**STOCKLEY CENTER
ALL STAR BUILDING
WINDOW REPLACEMENT
26351 PATRIOTS WAY, GEORGETOWN 19947
DBF #586B037.D01 ❖ OMB/DFM #MC3501000064**

August 12, 2019

ADDENDUM NO. 2

ELEVATION 1

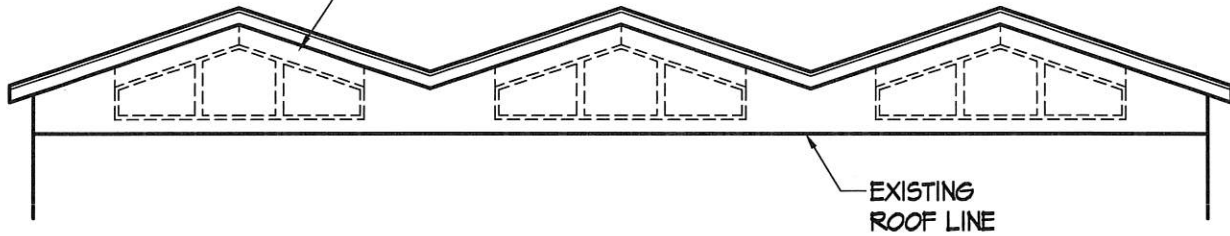
ABATEMENT CONTRACTOR SHALL REMOVE WINDOW UNIT,
CAULKING AND METAL TRIM (TYP OF 3)

ELEVATION 2

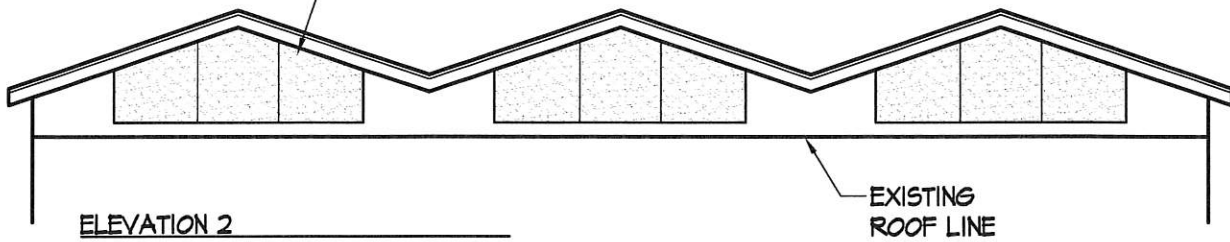
GC SHALL PROVIDE AND INSTALL +/- 33 SQ.FT. NEW
FRAMING, INSULATION, SHEATHING, WEATHER BARRIER,
DRYWALL AND METAL PANELS - SEE DETAILS ON SHEET
A3 FOR ADDITIONAL TYPICAL INFO. (TYP OF 3)

NOTE: THIS WORK SHALL BE INCLUDED IN THE BASE BID.
